RFI 366 - End Diaphragm @ Girder 2

**RFI/FIELD DESIGN CHANGE/DESIGN DIRECTIVE**

Drawing Package Title: Ramp A5

END DIAPHRAGM DESIGN AT GIRDER 2

**GIRDER 2 TO DOUBLE ANGLE CONNECTION:**

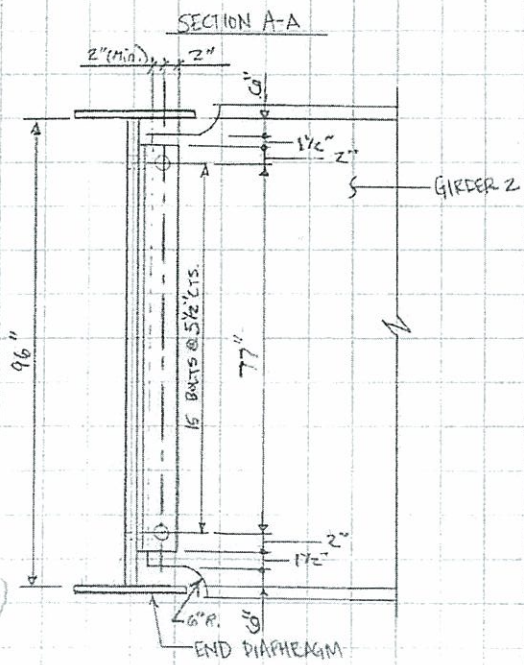
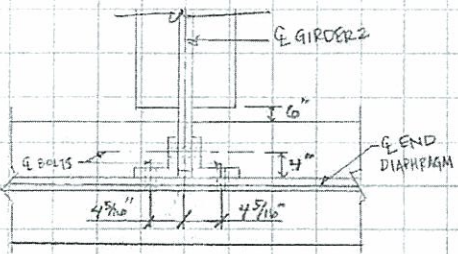
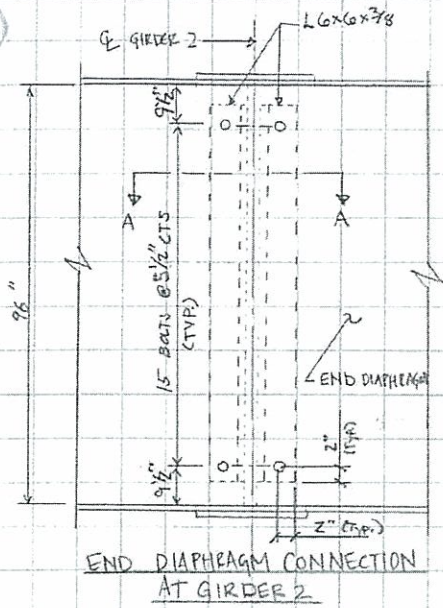
There is a 3/4" gap between the end of girder 2 and the end diaphragm located in span 3. The contractor would like to use a 3/4" shim plate to compensate for the gap.

Use AASHTO 6.13.6.1.5 to modify the bolt shear capacity for inclusion of the shim plate. Check that the modified capacity still exceeds the factor loading. There will be no impact to the slip resistance of the connection due to the shim plate.

$\therefore \phi R_n^* = 0.60 \times \phi R_n$   
 $= 0.60 (859)$   
 $= 515 \text{ k} > R_u$

The shim plate may be used.

SUPERSTRUCTURE DETAILS BRIDGE NO. CUY-90-152 I-50 RAMP AS		RID NO. 77322/85531	32 / 52
	BRIDGE RAMP AS		CUY-90-14, 90	0
NO. REVISIONS DATE	REVISIONS DATE	DATE	DATE	DATE

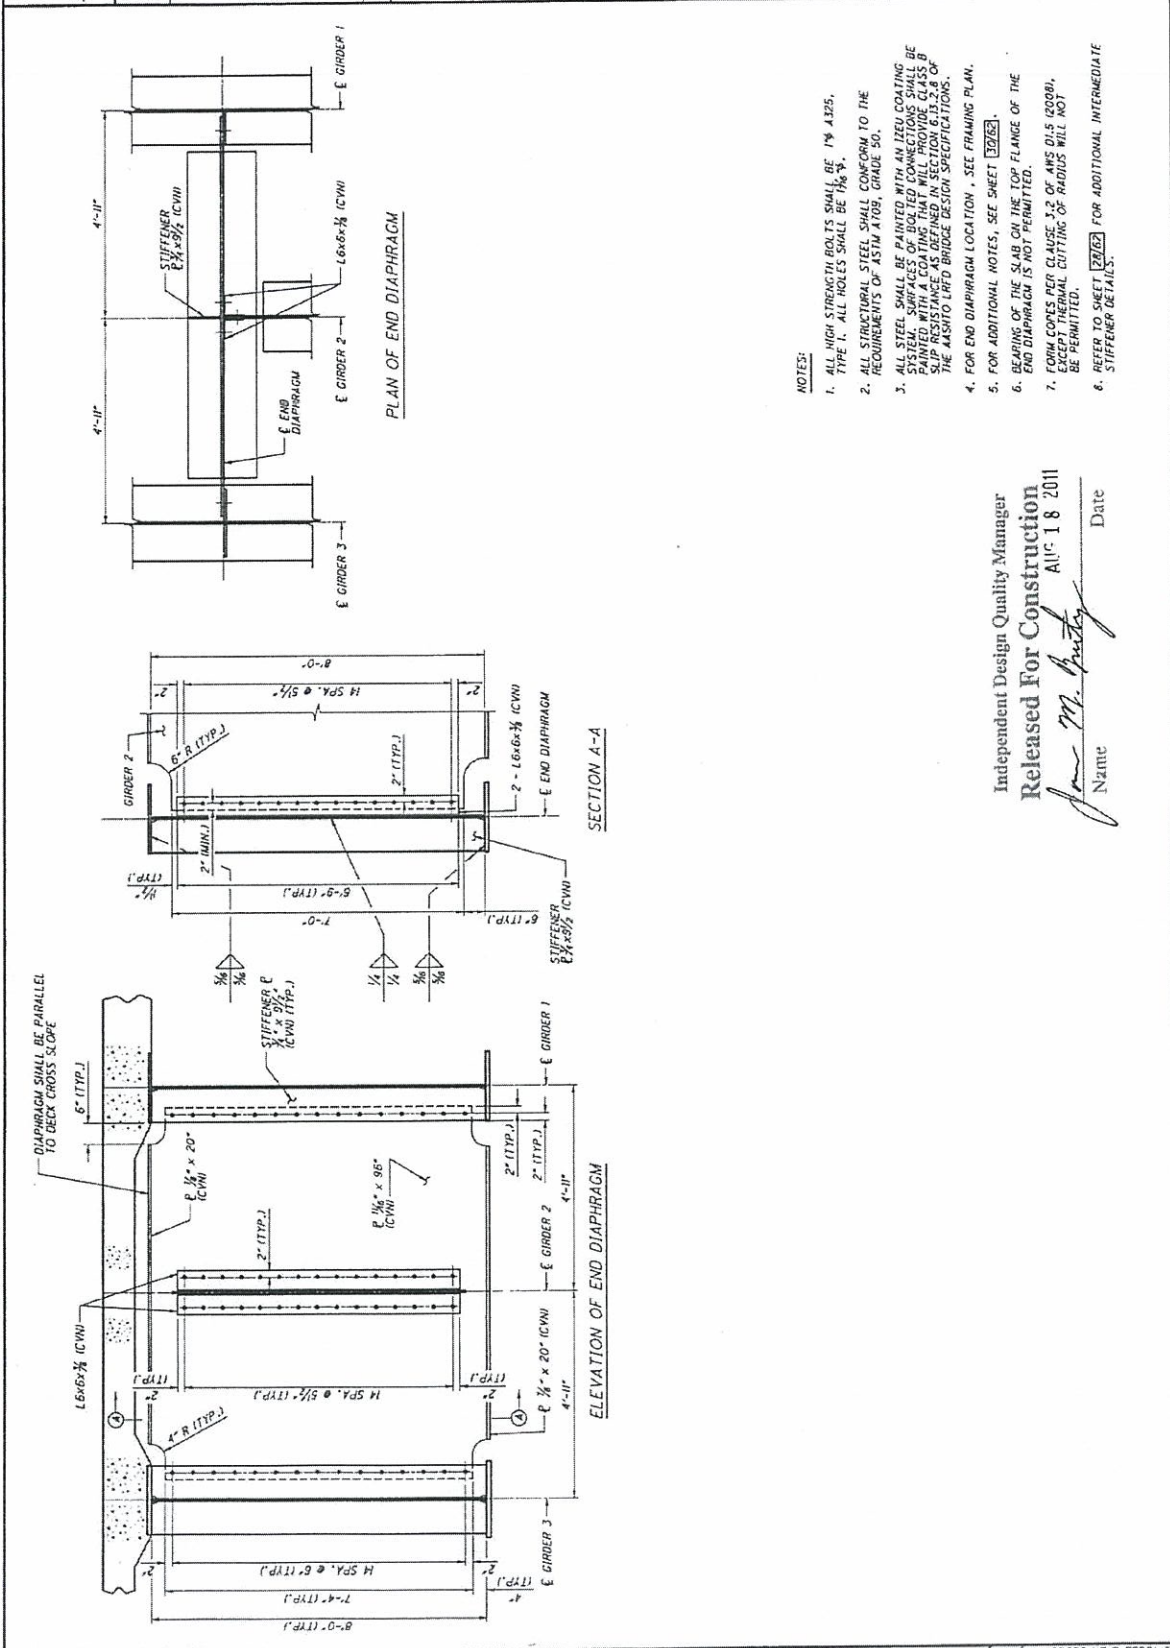
Description of Change: G2E on Ramp A5 is short of the plate diaphragm PD1. We moved the PD1 to the other side of the stiffeners and it is still short by  $\frac{3}{4}$ ".

Requested Change: We would like to install a  $\frac{3}{4}$ " shim plate between the 6x6 angles and the PD1. We would also need to up size bolt length from 2-3/4" to 3-1/2". Is this acceptable?

Response: *HNTB takes no exception to the use of # a shim plate as described above. The shim plate shall be coated per note 3 on sheet 32/022 of the ~~des~~ RFI Plans.*
